ADDENDUM NO. 4

February 10, 2023

SOLON ROBINSON ELEMENTARY SCHOOL ADDITIONS, RENOVATIONS, AND RELATED WORK Crown Point, IN 46307

Thursday, 2/9/2023 — 1:33 PM — LAST SAVED BY:PDEGR Y:\21—109 CROWN POINT CSC — ROBINSON ES IMPROVEMENTS\21—109 DRAWINGS\05 ARCH\A—602.DWG

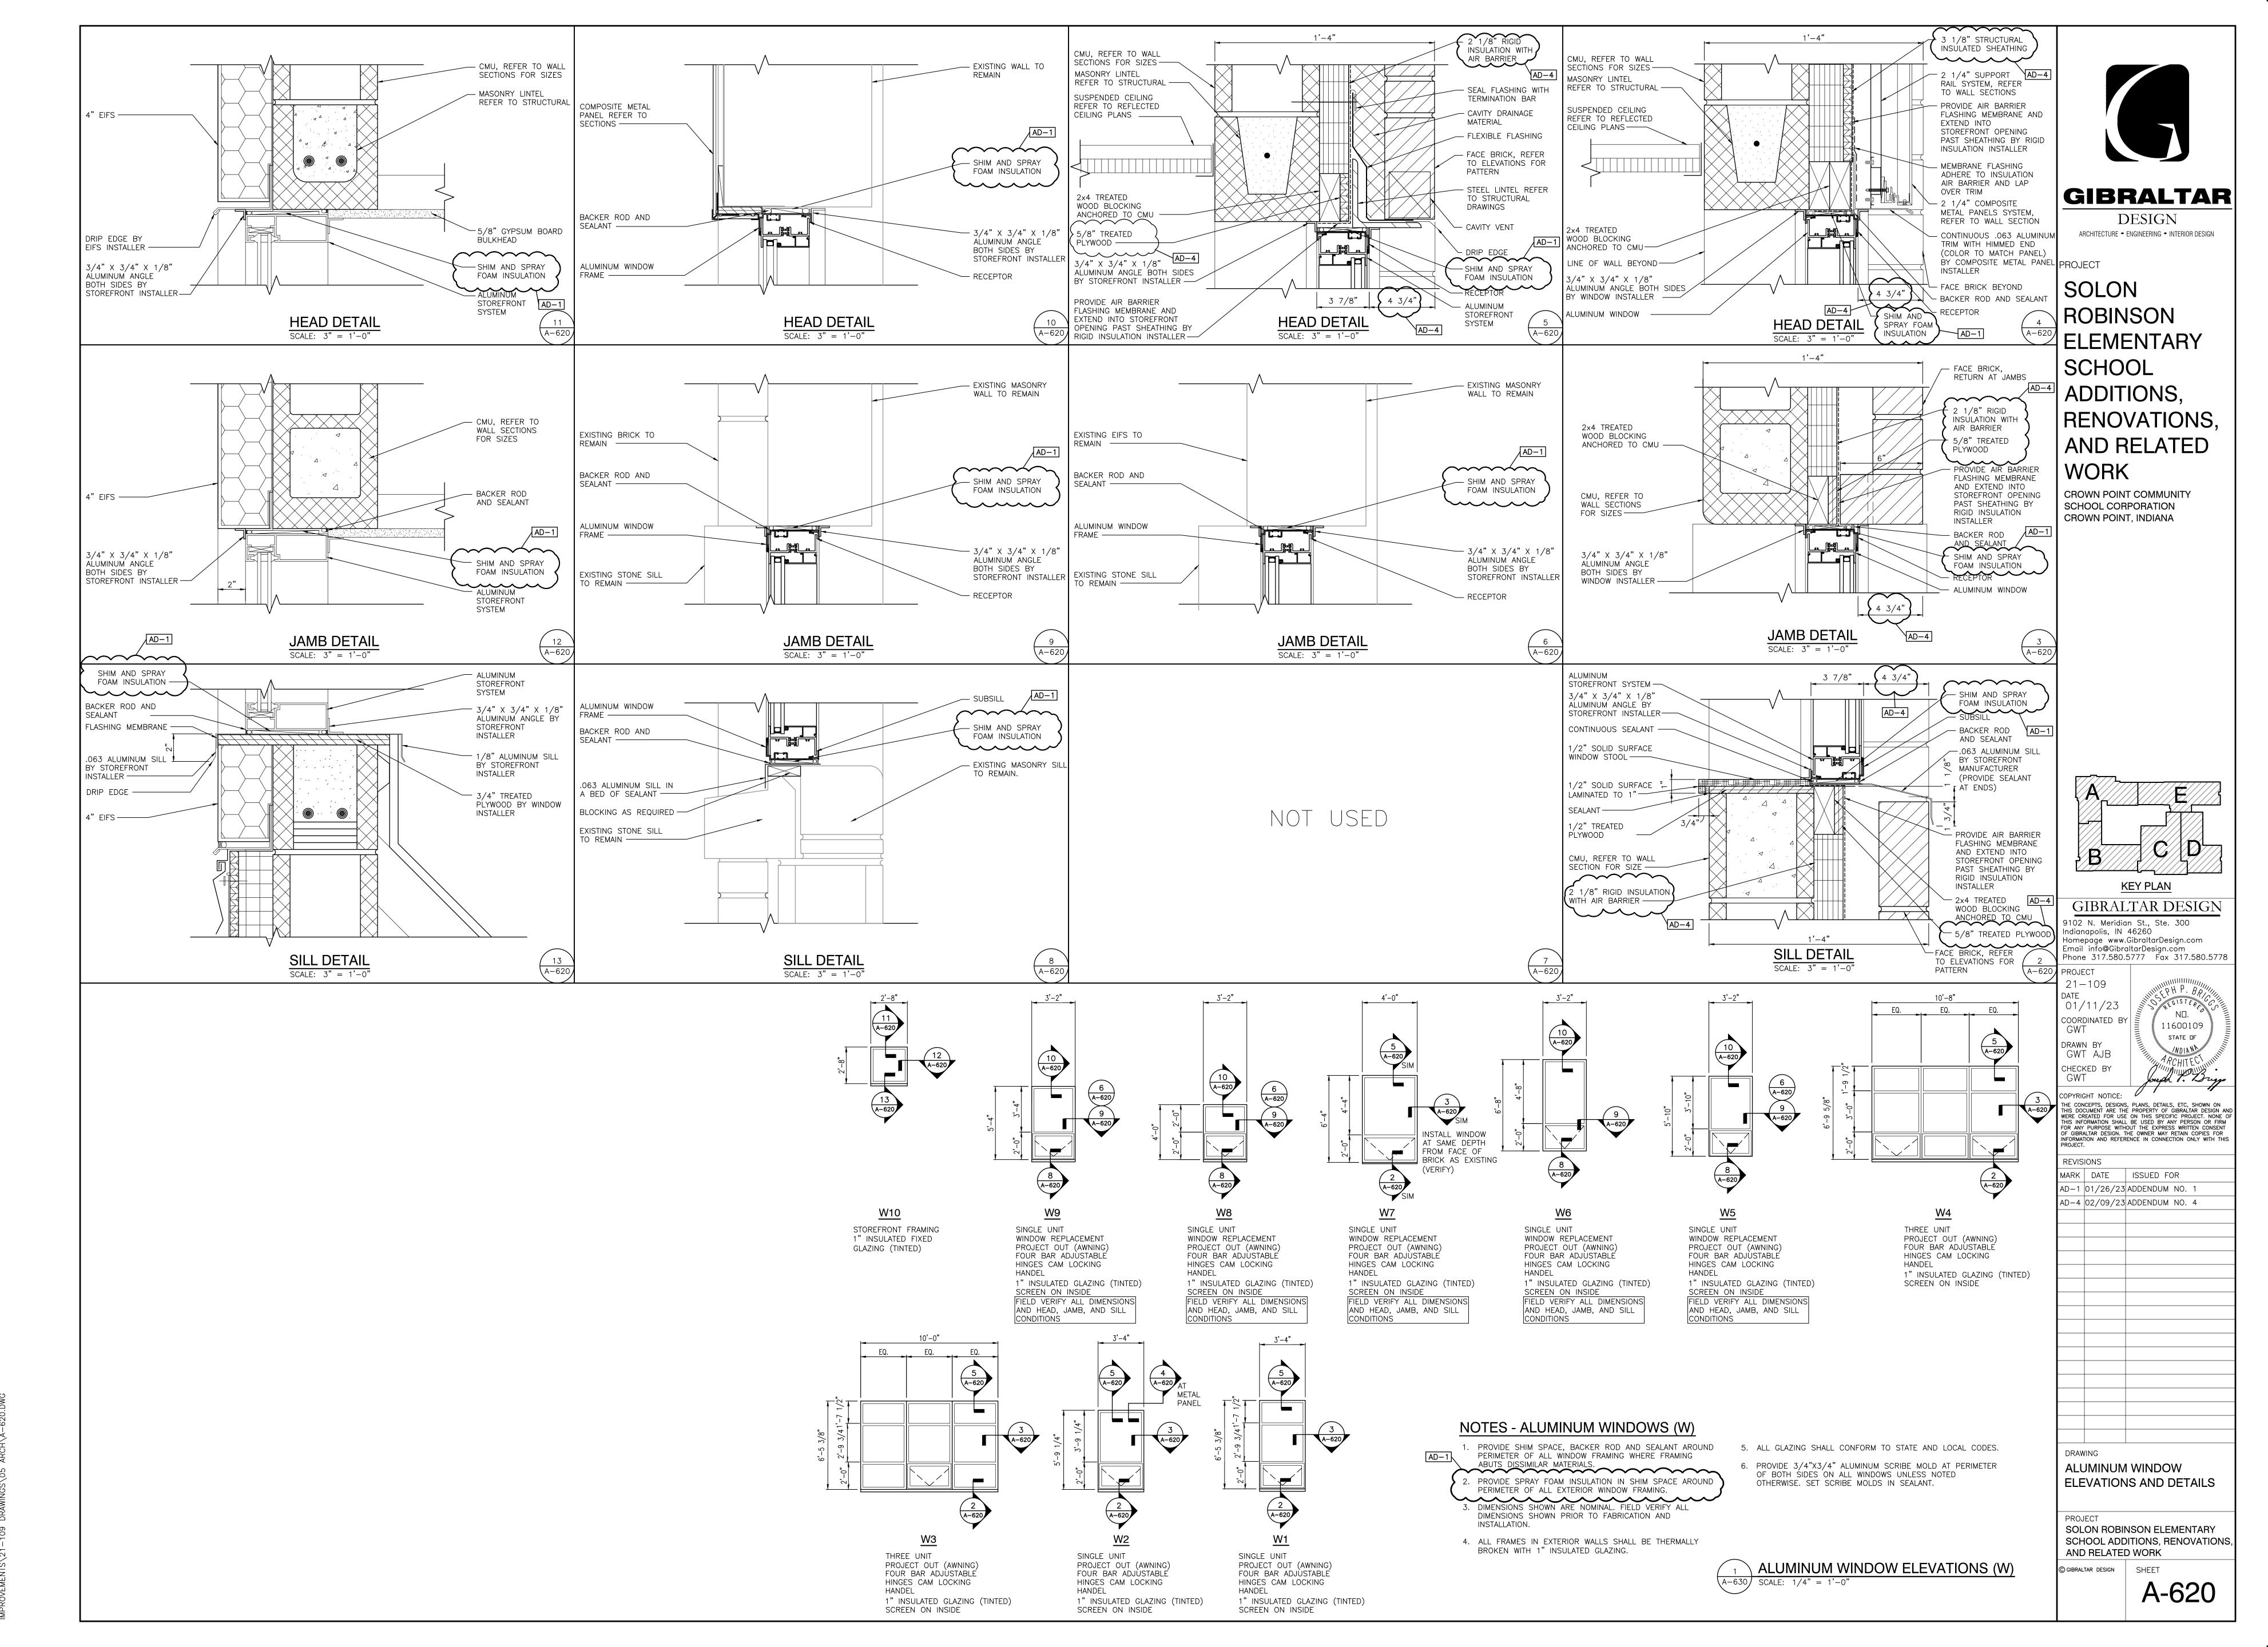
19. Sheet A-602

A. Hollow Metal Frame Elevations (HM): Revise elevation HM5.

Inursday, Z/9/2023 — II:39 AM — LASI SAVED BY:PDEGROIP Y:\21—109 CROWN POINT CSC — ROBINSON ES MPROVFMFNTS\21—109 DRAWINGS\05 ARCH\A—703 DWG

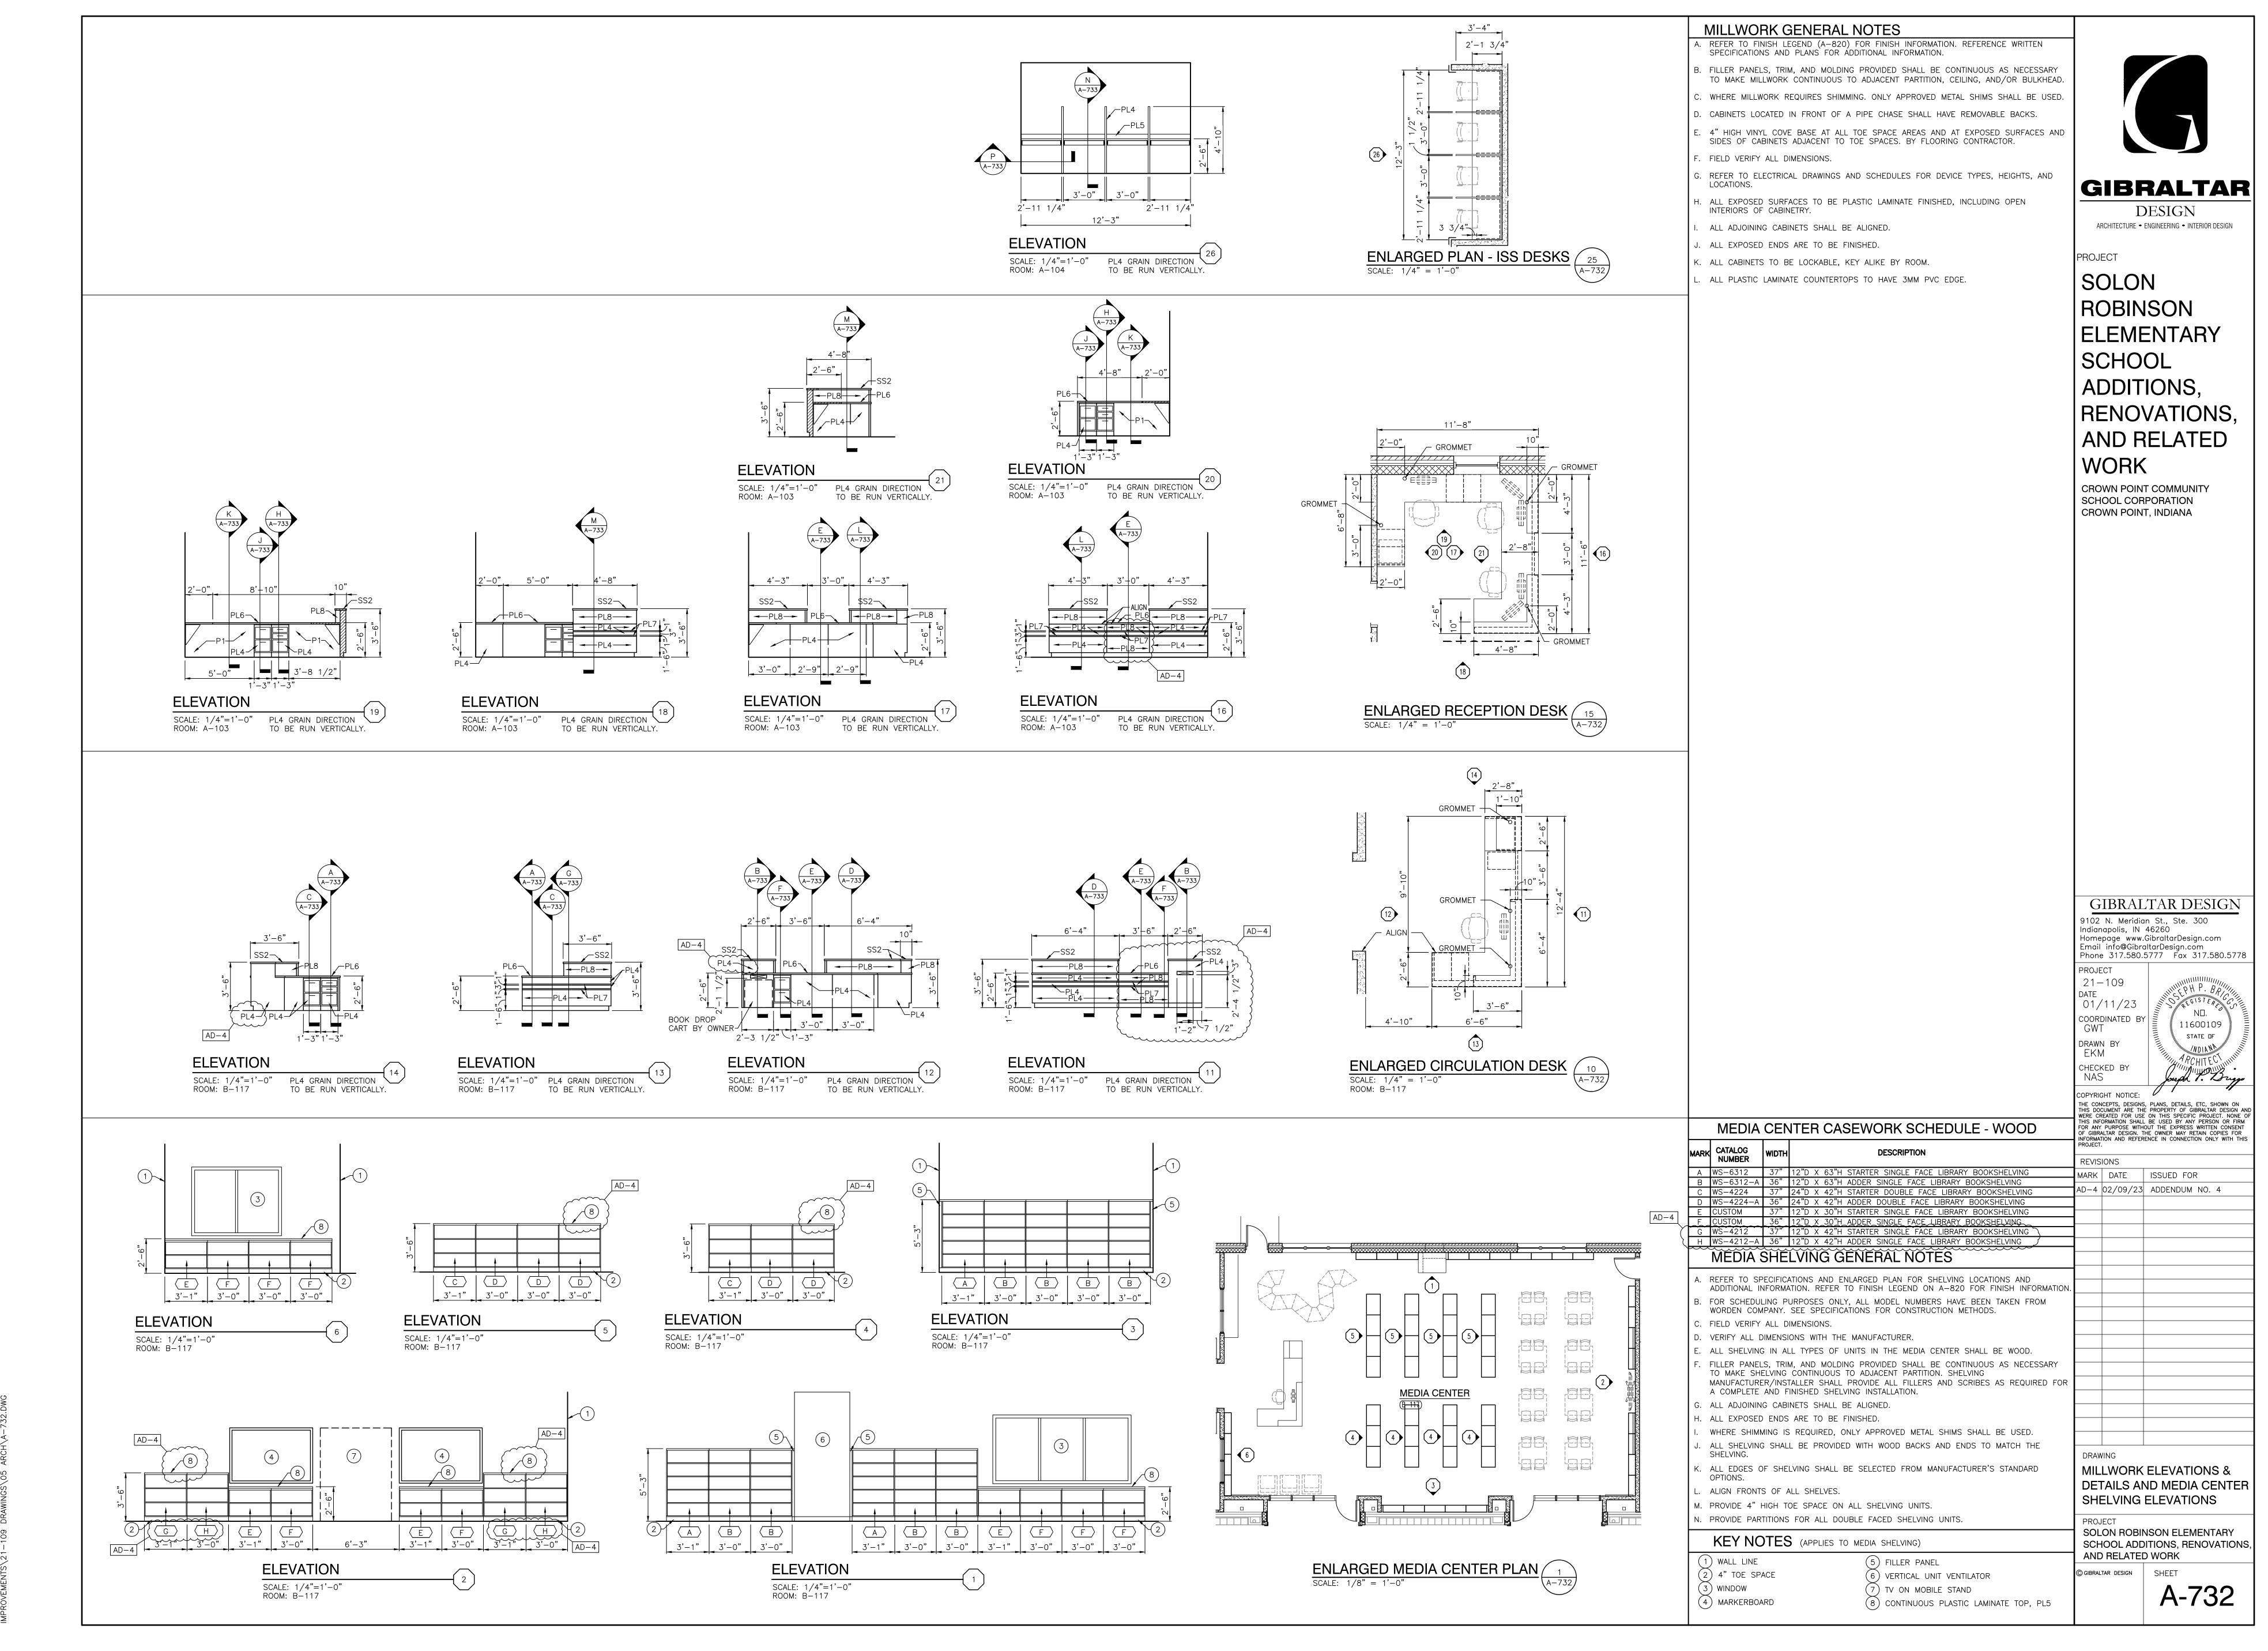
21. Sheet A-703

A. Equipment Plan Notes: Revise Note "3" regarding basketball backstops.

© GIBRALTAR DESIGN SHEET A-860

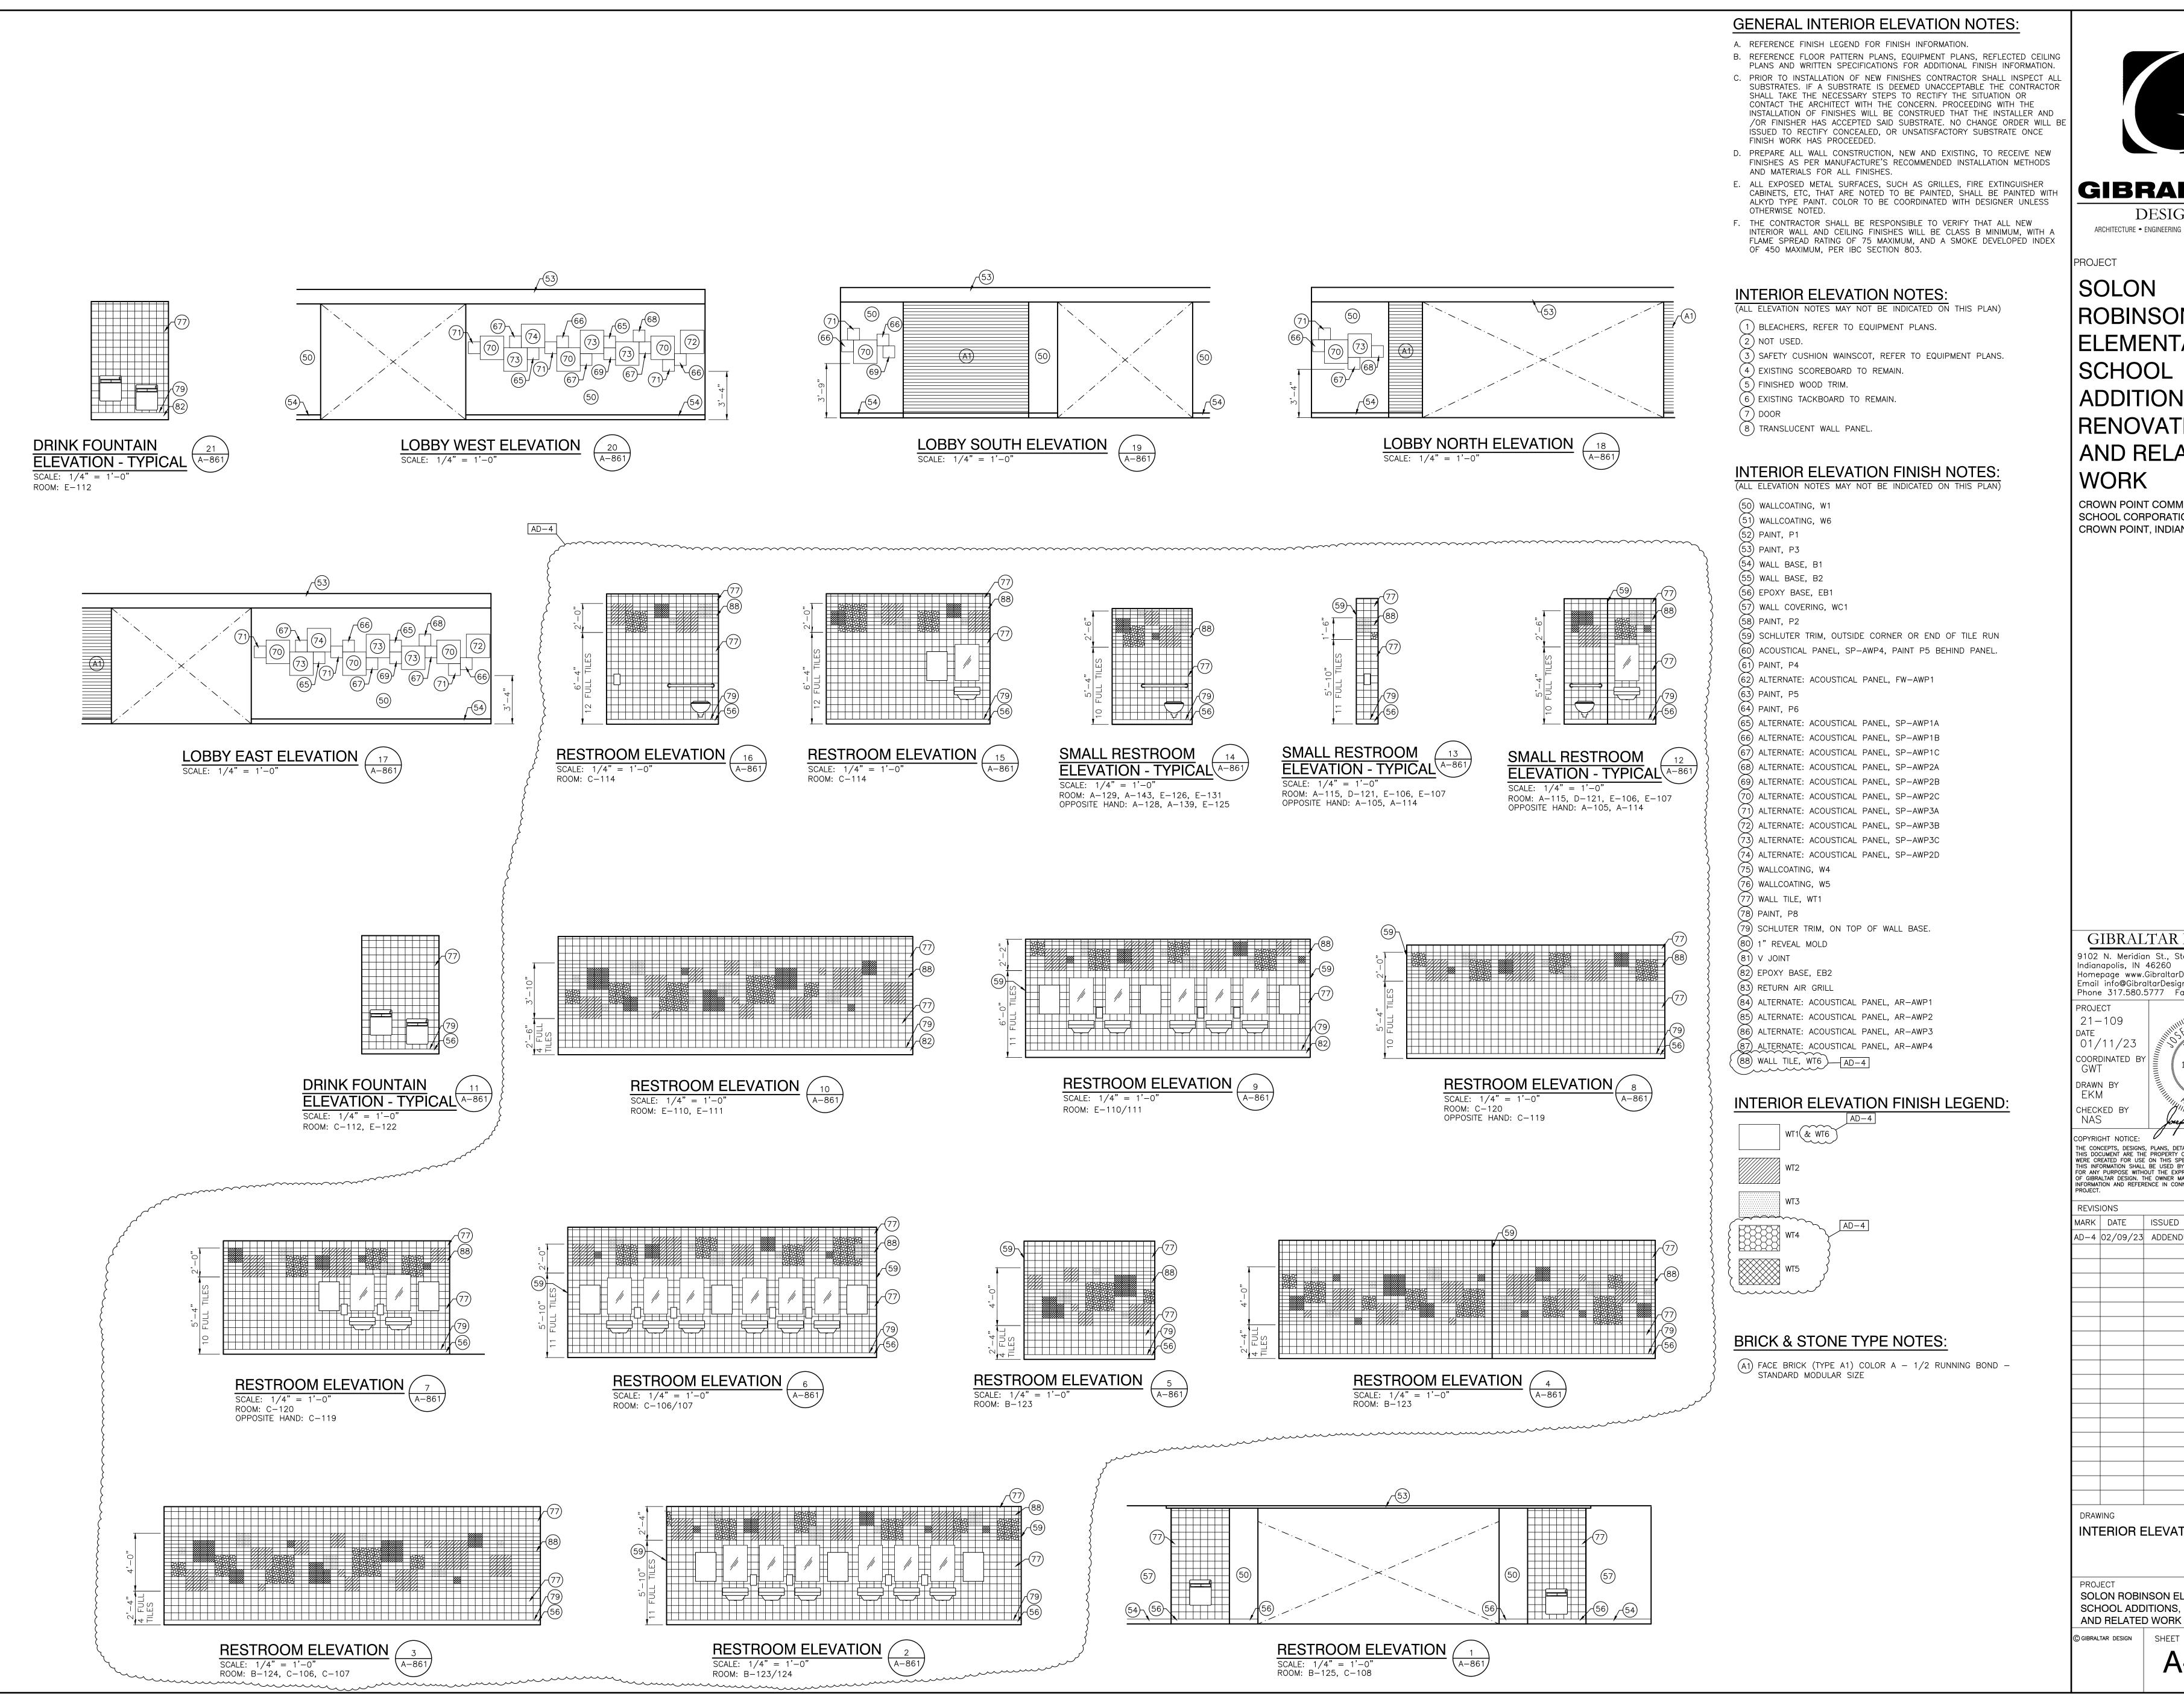
26. Sheet A-860

A. Add Keynotes 84 through 87.
